Sheringham Shoal and Dudgeon Offshore Wind Farm Extension Projects

Flood Risk at Matlaske Road Technical Note

Document Reference: 14.33

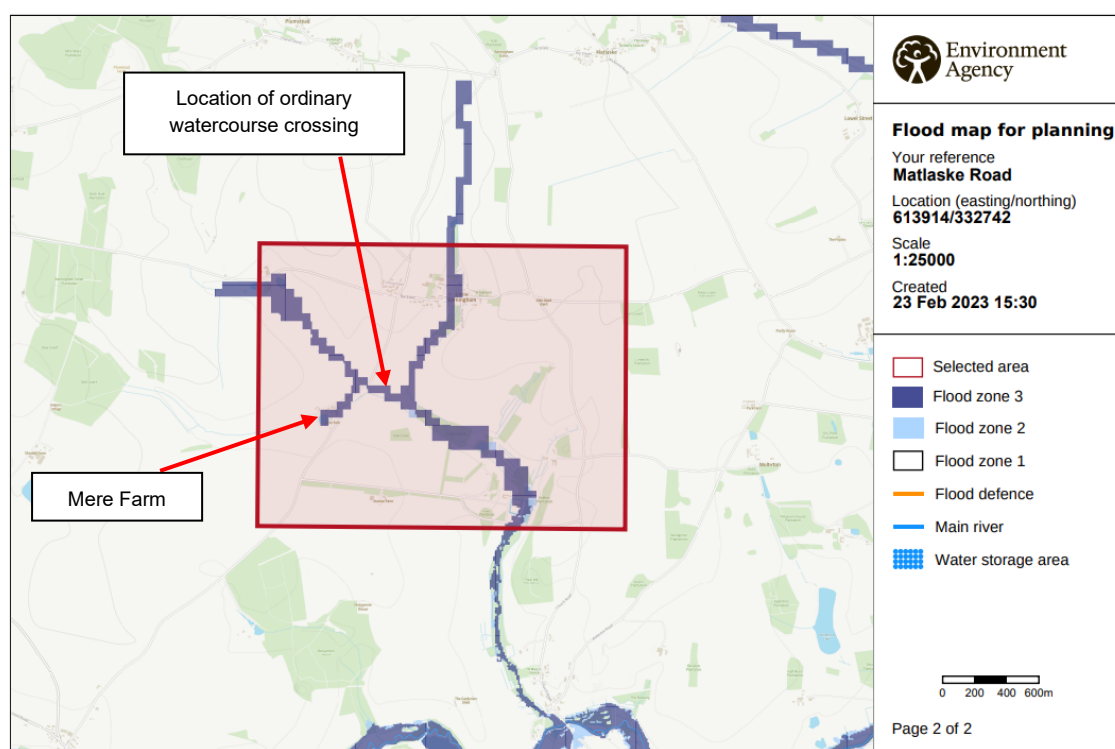
Figure 18.5

This identifies the proposed crossing method at each location. There is a crossing of an ordinary watercourse southwest of Little Barningham where it appears that open cut trenched techniques are proposed. As noted in our comments for Table 18.14, the assessment used to determine a trenched crossing at this location didn't include an assessment of flood risk impacts. Immediately upstream of this crossing location are a number of properties in fluvial Flood Zone 3a and we also note that this area is within the flood alert area for The River Bure, Spixworth Beck and surrounding Becks.

Figure 6-2: Flood Zone 3 extent and 1m LiDAR Comparison

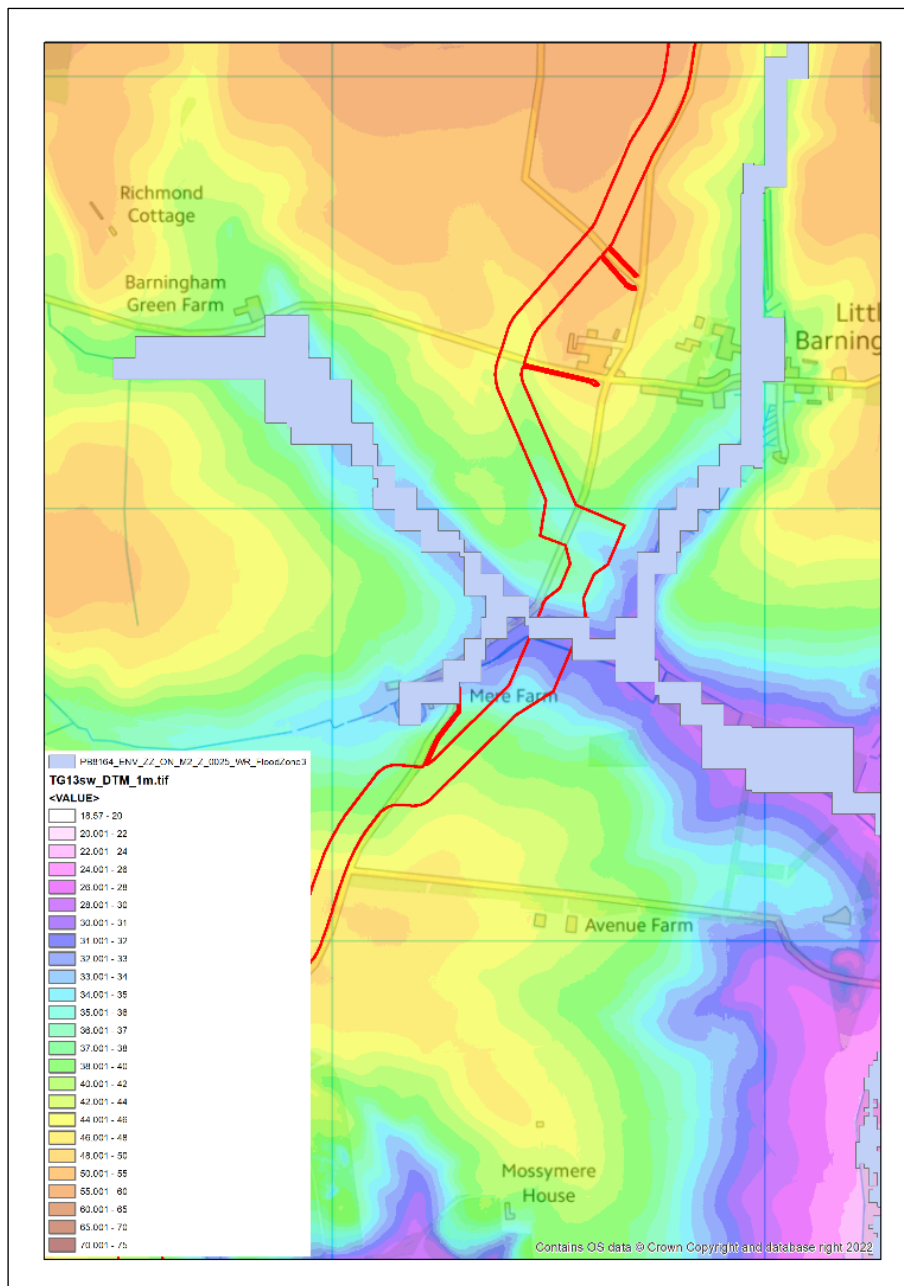
There is a potential increase of flood risk to several homes arising from the use of trenched techniques at this crossing. Based on the current proposal, an assessment of the flood risk impacts of this trenched crossing is required in the Flood Risk Assessment for the Environment Agency to review and agree to before the conclusion of the examination process. Alternatively, we recommend that this crossing is undertaken using trenchless techniques (HDD) to avoid flood risk impacts, which should negate the need for an assessment. We have suggested this solution the Applicant's representative and await their response.

38. A comparison was made between the LiDAR and the Flood Zone 3 extent, which is shown in **Figure 6-2**. This comparison shows that some of the areas appearing to fall within Flood Zone 3, are at a higher elevation than some areas shown to be outside of Flood Zone 3.

39. For example, land immediately south of Barningham Green Farm is at an elevation of approximately 34.0m ODN to 35.0m ODN, however, it appears to be within Flood Zone 3.

40. In comparison, immediately to the east of Mere Farm the ground level is approximately 31.0m ODN to 32.0m ODN. However, this appears to be outside of the Flood Zone 3 extent.

41. This comparison highlights the relatively poor resolution of the JFLOW mapping which also appears to be inconsistent with the topography in this local area, potentially incorrectly identifying flood risk receptors.
42. Given the left bank of the ordinary watercourse, within the Order Limits is lower than the right bank, the limited connectivity with the downstream floodplain and depth of water required to flood the farm buildings at Mere Farm, it is considered that the flood risk in this location is not as extensive as the Environment Agency Flood Map for Planning, based on the JFLOW outputs.
